**SECTION 00 90 04
BIDDING AND CONTRACT REQUIREMENTS
ADDENDUM NUMBER 4**

Issued: October 12, 2023

Re: ADDENDUM NUMBER (4) TO THE BIDDING DOCUMENTS FOR

**McHenry County College
University Center at MCC**
Architect's Project Number: 22-050

NO.	DESCRIPTION:	DATE:
3	Addendum #4	10/12/23

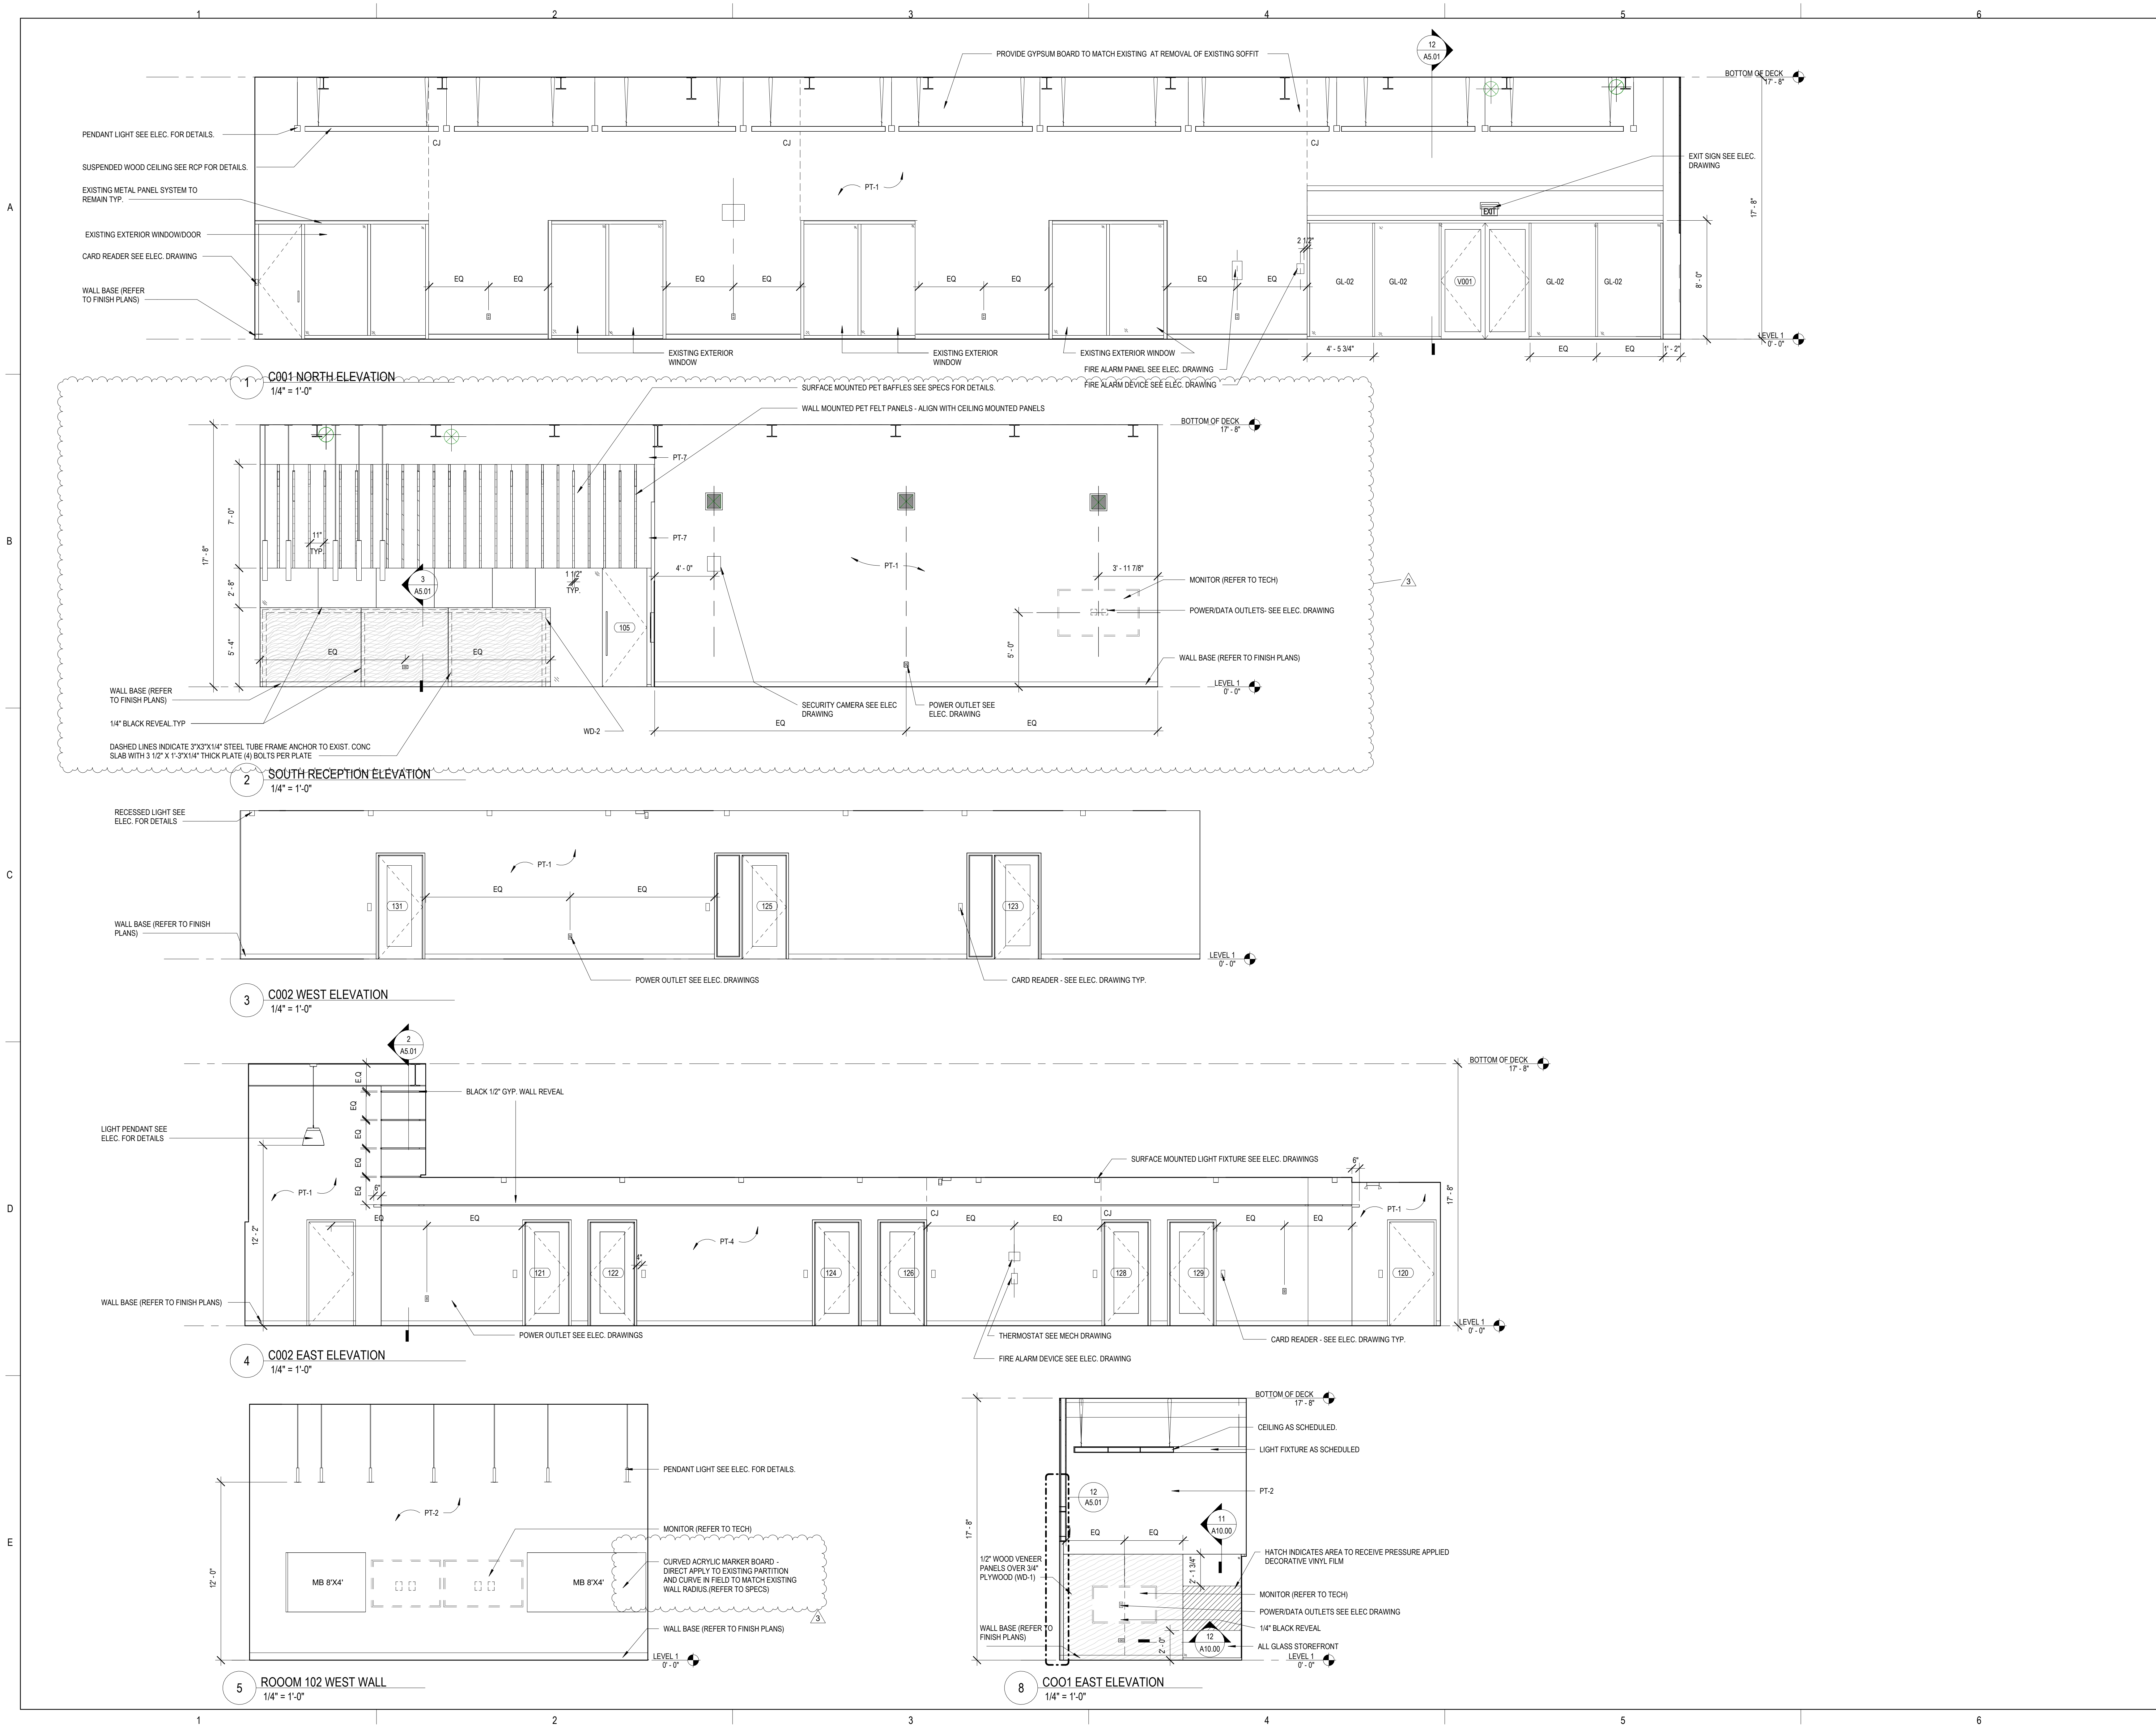
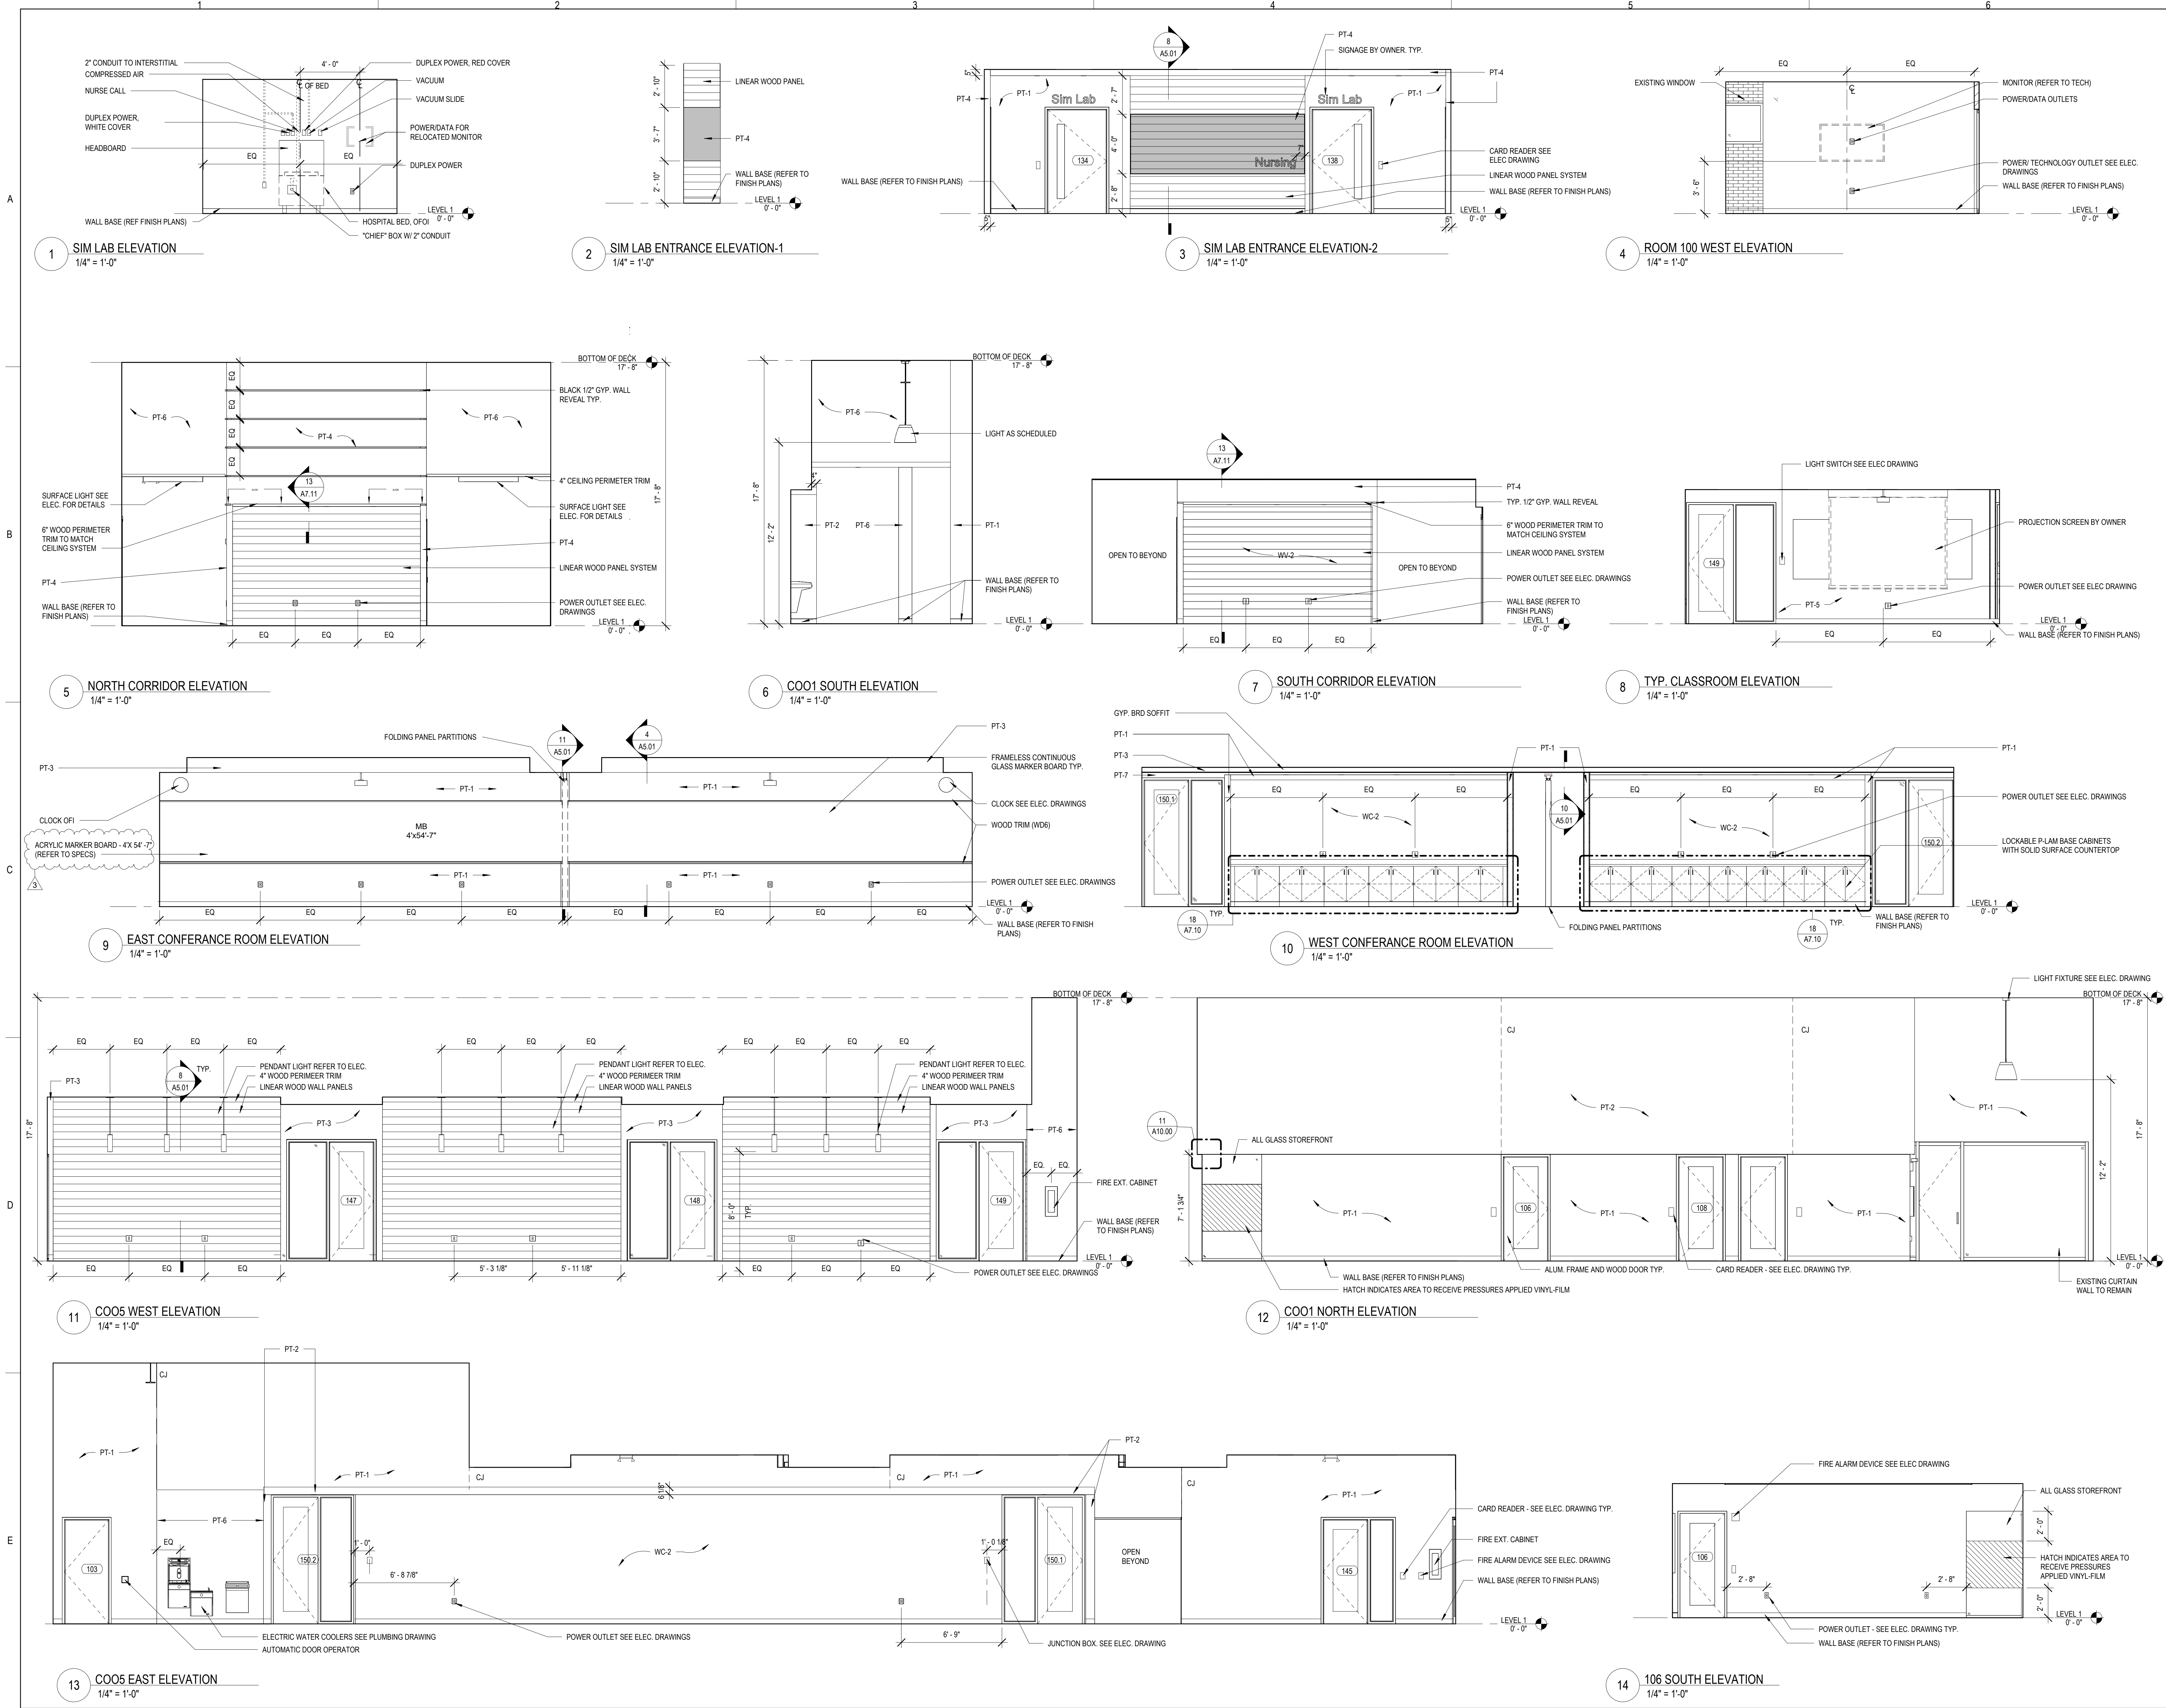
4. A2.51
 - A. **REVISE** enlarged RCP #1 as indicated.
5. A5.01
 - A. **REVISE** section 3 and 4 as indicated.
6. A7.10
 - A. **REVISE** details 7, 11, 12, 14, and 16 as indicated.
